TOWN OF COTTESLOE – TOWN PLANNING SCHEME NO. 2

POLICY No. 14 – LOCAL DEVELOPMENT PLAN FOR FORMER DEPOT SITE

Local Development Plan

Former Cottesloe Works Depot
2B (Lot 34) Nailsworth Street, Cottesloe

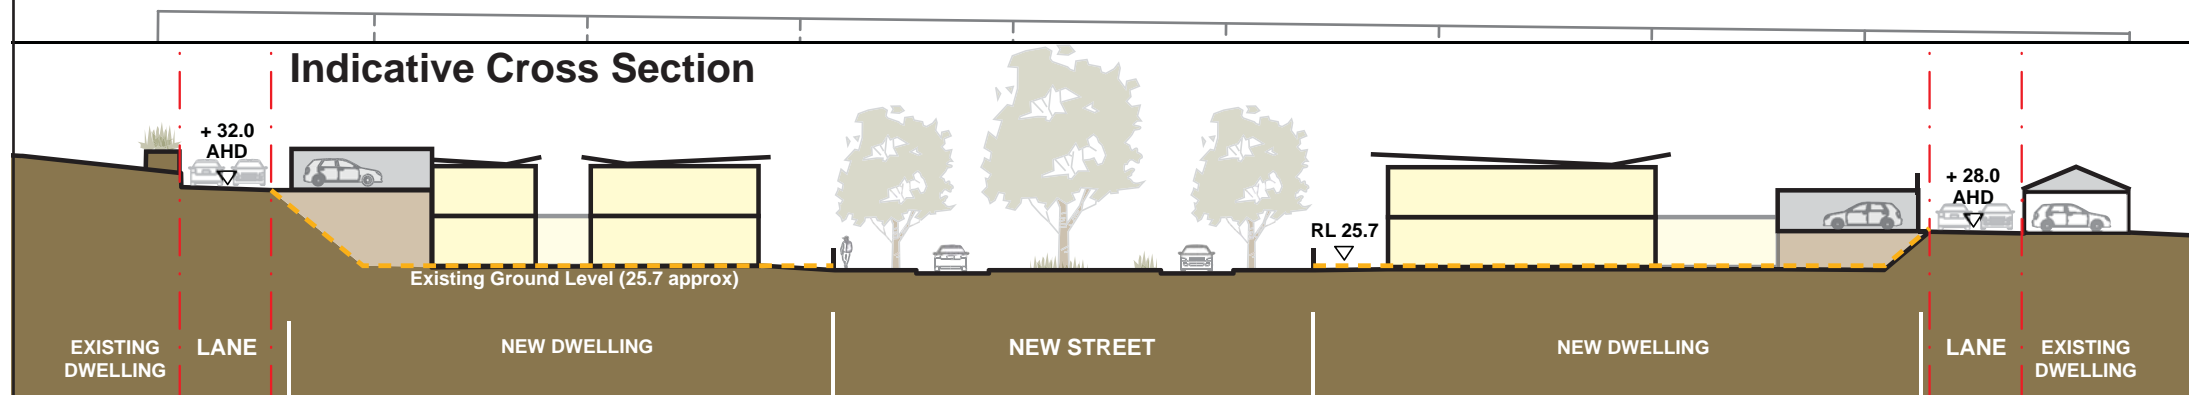
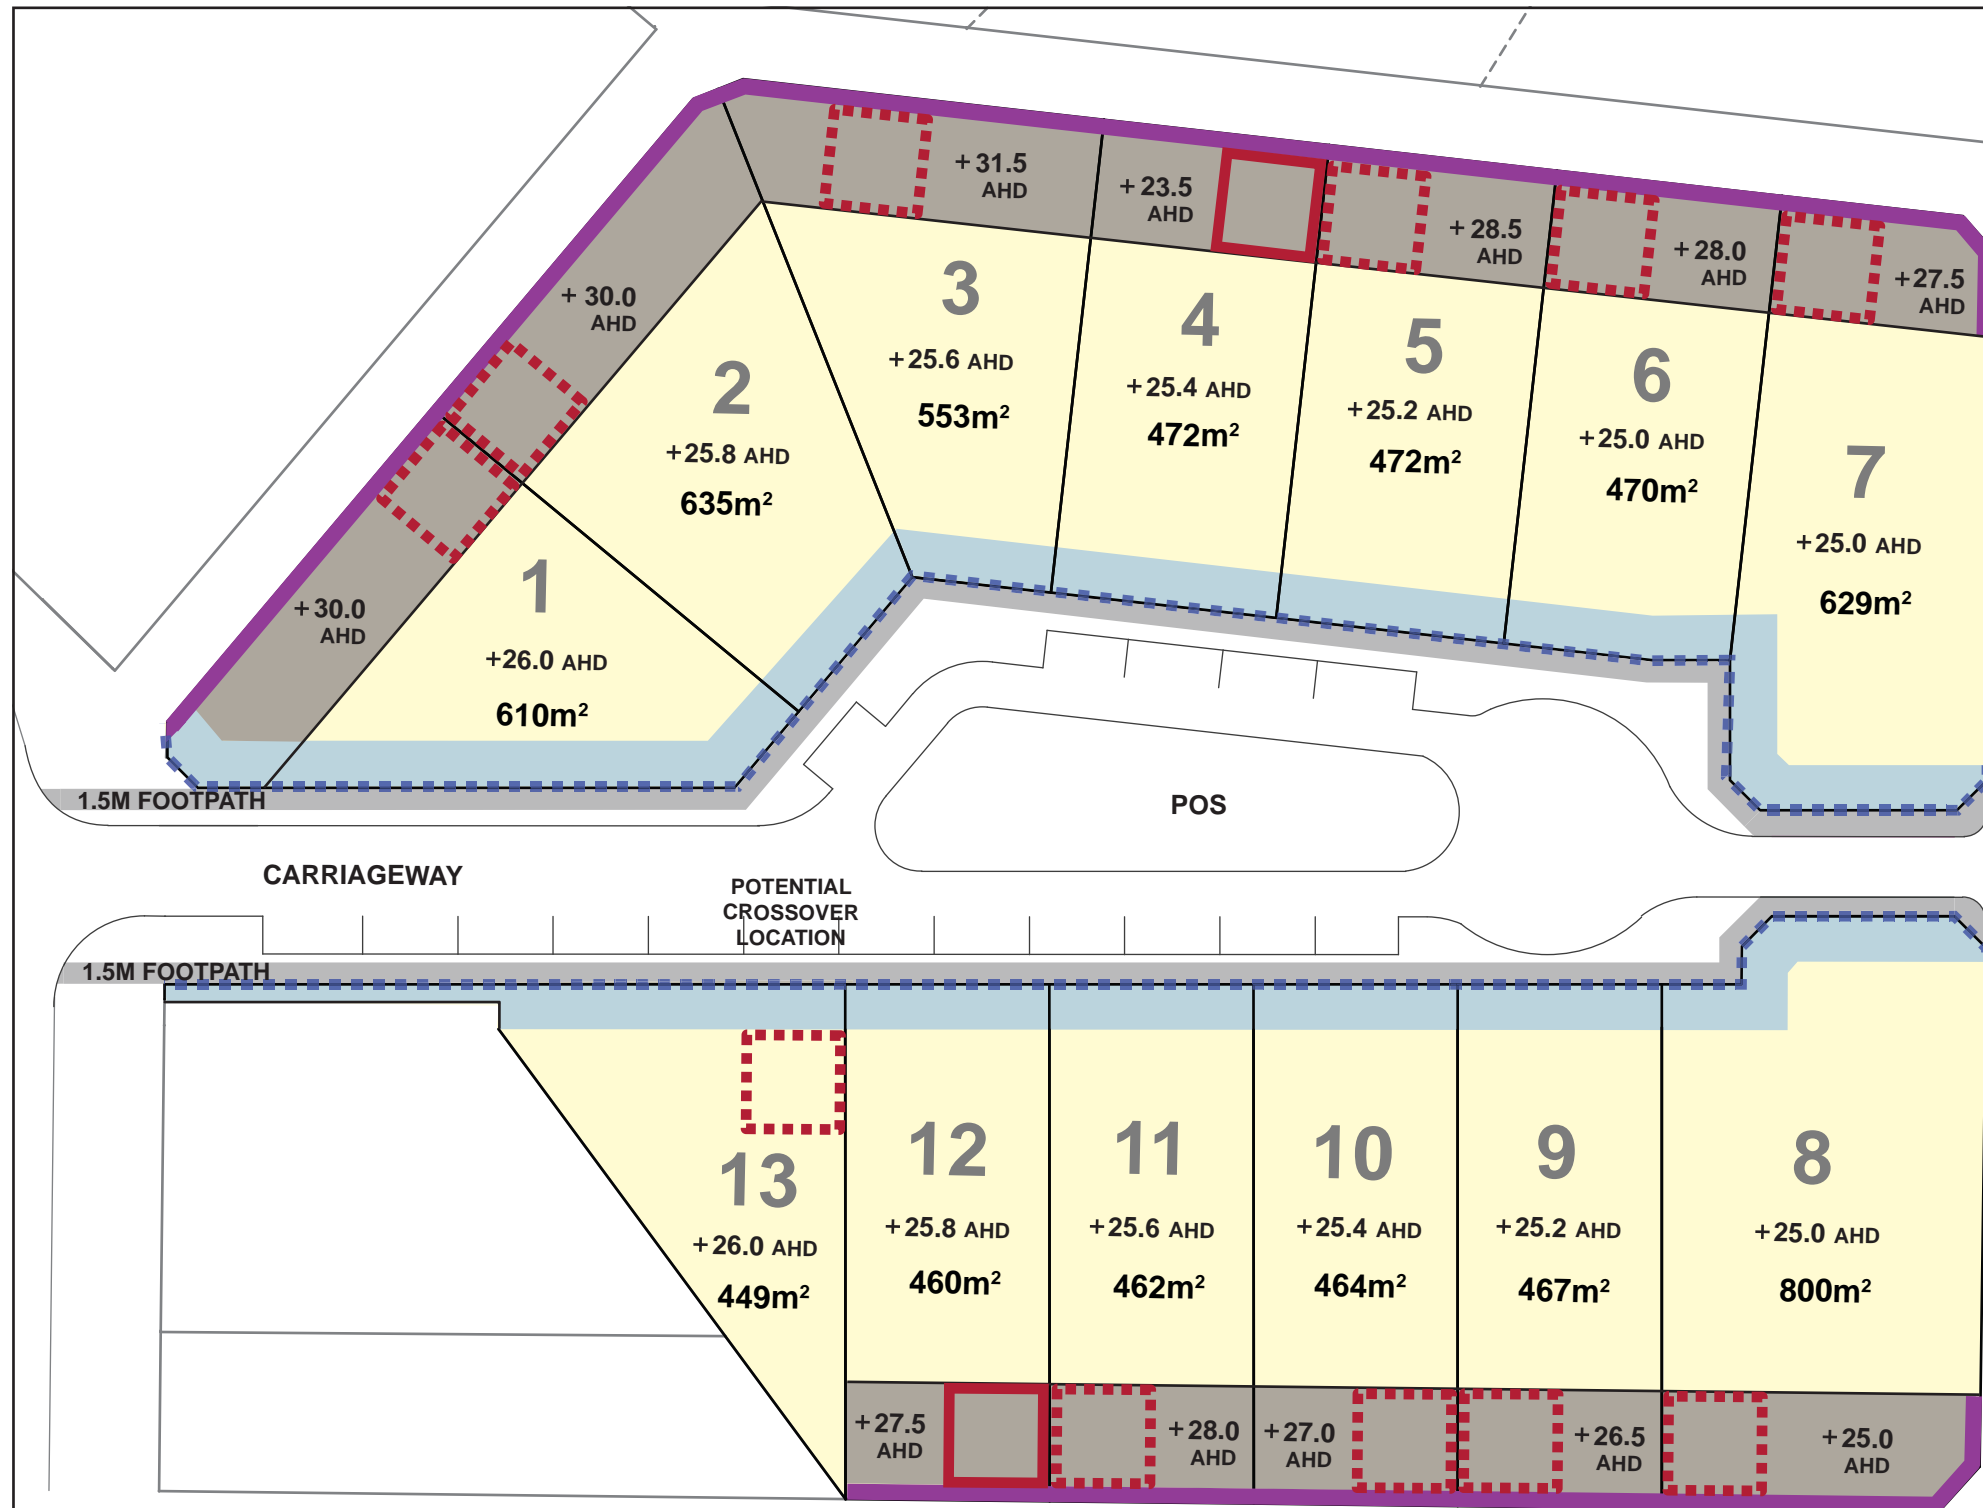
Cottesloe Depot site LDP
Comments The following comments are offered in relation to the Local Development Plan: The value of the northern laneway is questionable given that, unlike the southern laneway, it does not exist in its entirety, is not used by all of the existing adjacent residents, and aligns along ?challenging? topography. Furthermore, the establishment of the northern rear lane will require a significant amount of fill and retaining wall construction, which, in turn, will give rise to significant construction nuisance. The slope of the laneway if constructed may also require the garages to be setback further than the nominal 1 metre to allow for a length of driveway to accommodate the transition from a sloping laneway to a flat garage floor. The elevation of the rear portion of the northern lots will result in garages that are so high as to be inconveniently divorced from the houses they serve. Given the prospect of a garage inconveniently located, in some cases, a full storey and a half above the main house, most purchasers may prefer a conventional garage at ground level accessed from the street on the southern side. Additionally, the retaining wall for the upper portion of the northern lots will cause significant overshadowing of outdoor living areas that are most likely to be located at the rear of the main house. It is unclear as to whether the intended tenure of the central open space is Public Open Space, road reserve or both. Whilst some local parks are located in road reserves, a formal designation as ?Public Open Space? would provide greater certainty on the long-term use of the space as a local park. There is no explanation as to why the garage locations for Lots 4 and 12 are mandated whilst the garage locations for all the other lots are only designated as preferred. Furthermore, the drafting of the plan implies, but does not confirm, that with the exception of Lots 4 and 12, the option still exists for purchasers to locate garages at the front of the lots in preference to the rear of the lots. If this is the case, the northern laneway may well become redundant. There is no explanation as to why garages can be up 5 metres high. Not only is the 5-metre allowance for a garage structure inconsistent with the indicative cross section graphic that suggests garages are low flat-roofed structures, a 5-metre high structure will impact on the existing views of existing residences, particularly to the north of the site. Given the sensitivities of the existing residents to the north who have a view over the development area to the John Street pines and beyond, garages with a low-pitched or flat should be mandated. The drafting of the LDP note on drying courts may be improved. As drafted, there is an implication that drying courts are permissible in the front yards (albeit behind the setback line). It is not good urban design practice to locate drying courts or other private or service courtyards at the front of a property. Instead of allowing a 1.8-metre wall as an address to the street, the LDP and any supporting design guidelines should require drying courts and other courtyards to be to the side or rear of the dwelling. The allowable site coverage of 65% is inconsistent with the provisions of an R20 zone under the R-Codes. Whilst this may not be a

Garaging There is no explanation as to why garages can be up 5 metres high. Not only is the 5-metre allowance for a garage structure inconsistent with the indicative cross section graphic that suggests garages are low flat-roofed structures, a 5-metre high structure will impact on the existing views of existing residences, particularly to the north of the site. Given the sensitivities of the existing residents to the north who have a view over the development area to the John Street pines and beyond, garages with a low-pitched or flat should be mandated.

Comments -It is pleasing to see a reasonable amount of parking within the subdivision since parking options in surrounding streets are very limited. -It is concerning that most garages do not have to be at rear ? just ?preferred? that way. This is a change from previous discussions and leaves open the potential for garages to be built facing into the subdivision with the need for numerous crossovers. There may be some blocks where this is appropriate but the vast majority (particularly those on the southern blocks) should have rear garaging mandated. -garages with a low-pitched or flat roof should be mandated. A 5 metre height allowance seems excessive and will impact on neighbours. -We respectfully ask that Design Guidelines be put in place for the development. Design guidelines provide a degree of certainty in respect to the quality and character of development, which could have a bearing on the desirability of the surrounding area. Design guidelines also have the capacity to provide greater certainty in protecting the amenity of surrounding residents.

The elevation of the rear portion of the northern lots will result in garages that are so high as to be inconveniently divorced from the houses they serve. Given the prospect of a garage inconveniently located, in some cases, a full storey and a half above the main house, most purchasers may prefer a conventional garage at ground level accessed from the street on the southern side. Additionally, the retaining wall for the upper portion of the northern lots will cause significant overshadowing of outdoor living areas that are most likely to be located at the rear of the main house. We oppose any planning approval that support the location of garages at the rear of the northern lots.

There is no explanation as to why the garage locations for Lots 4 and 12 are mandated whilst the garage locations for all the other lots are only designated as preferred. Furthermore, the drafting of the plan implies, but does not confirm, that with the exception of Lots 4 and 12, the option still exists for purchasers to locate garages at the front of the lots in preference to the rear of the lots. If this is the case, the northern laneway may well become redundant.

There is no explanation as to why garages can be up to 5 metres high. Not only is the 5-metre allowance for a garage structure inconsistent with the indicative cross section graphic that suggests garages are low flat-roofed structures, a 5-metre high structure will impact on the existing views of existing residences, particularly to the north of the site. Given the sensitivities of the existing residents to the north who have a view over the development area to the John Street pines and beyond, garages with a low-pitched or flat should be mandated.

The drafting of the LDP note on drying courts may be improved. As drafted, there is an implication that drying courts are permissible in the front yards (albeit behind the setback line). It is not good urban design practice to locate drying courts or other private or service courtyards at the front of a property. Instead of allowing a 1.8-metre wall as an address to the street, the LDP and any supporting design guidelines should require drying courts and other courtyards to be to the side or rear of the dwelling.

The allowable site coverage of 65% is inconsistent with the provisions of an R20 zone under the R-Codes. Whilst this may not be a significant issue, the rationale for the increase in allowable site coverage should be provided.

The provision of 17 on-street bays for 13 dwellings is a very high ratio, and no rationale has been provided as to why such a large number of on-street bays has been provided. Given the sensitivities of the residents along Nailsworth Street in regard to traffic, the provision of a large number of bays could be seen as having the potential to encourage traffic movement into the new street.
